Product Change Notification: PCN-22-153850

Change of labeling process on our ALR PT and SPT series parts

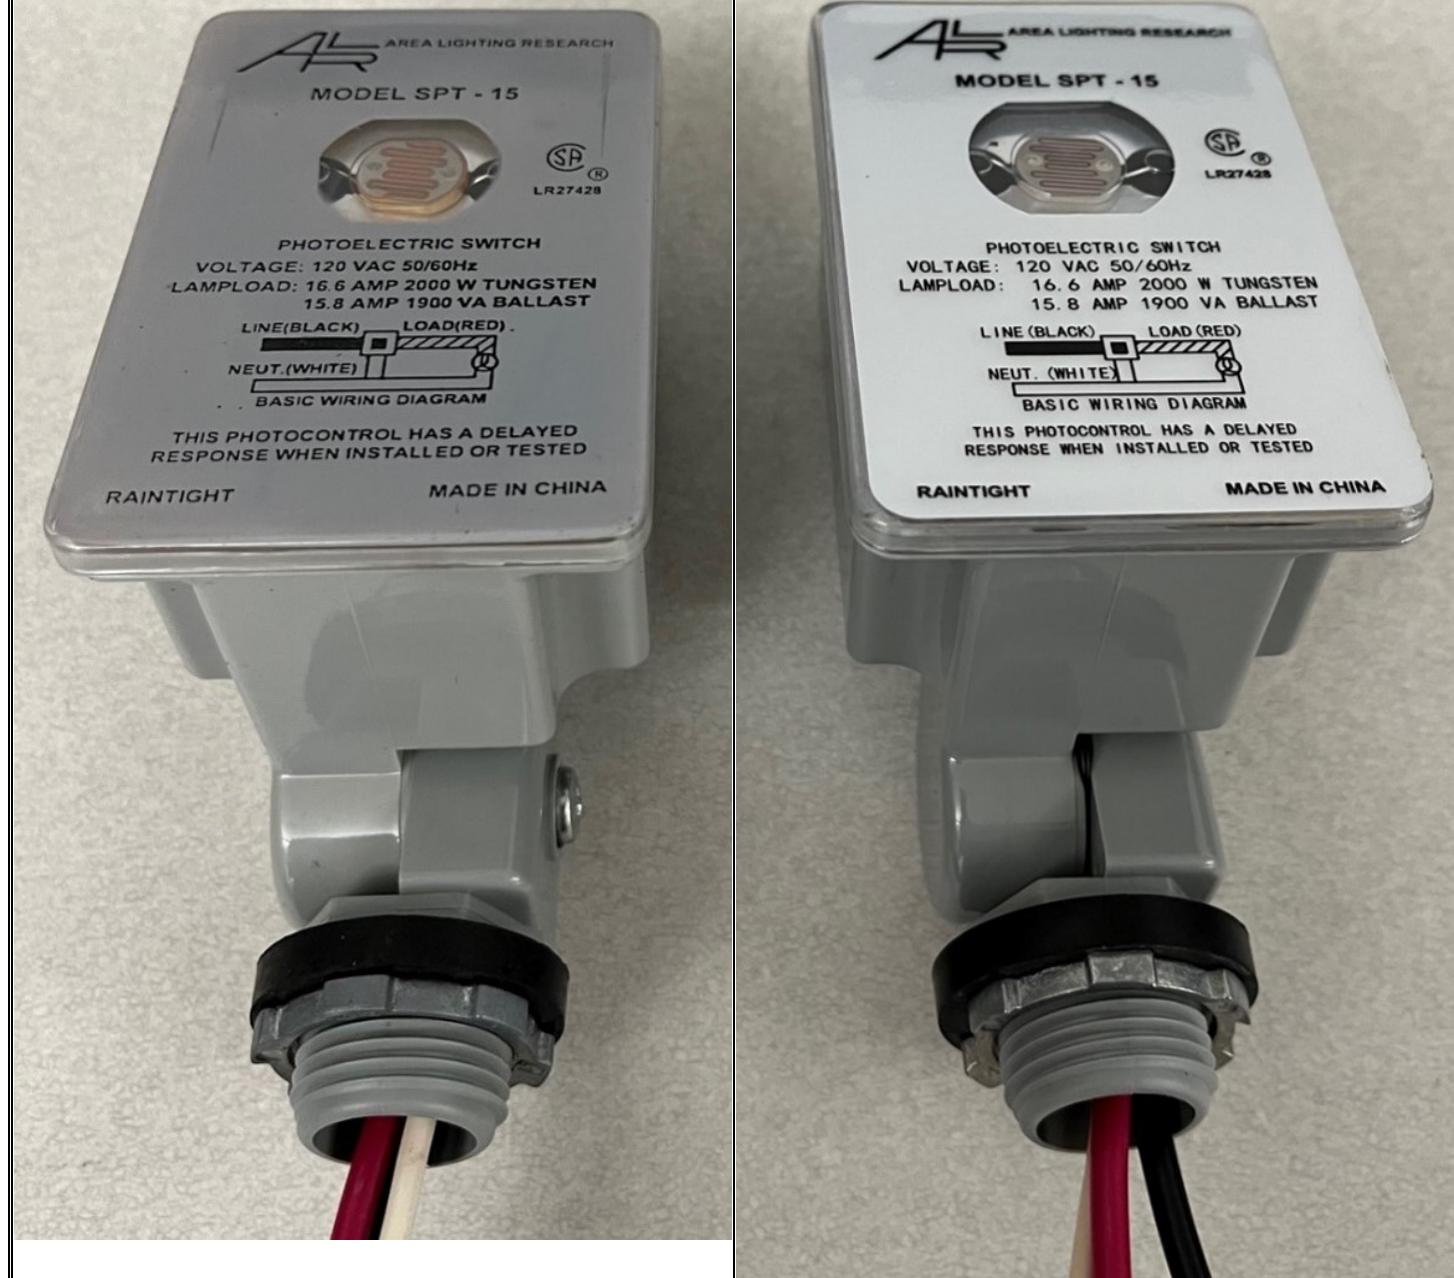
Please be aware of an upcoming cosmetic change to the listed part numbers (not affecting the function of the product). Before: Ink marked After: self-adhering label

ALR SPT Series current ink marking

ALR SPT Series new self-adhered label

ALR-PT Series current ink marking

ALR-PT Series new self-adhered label
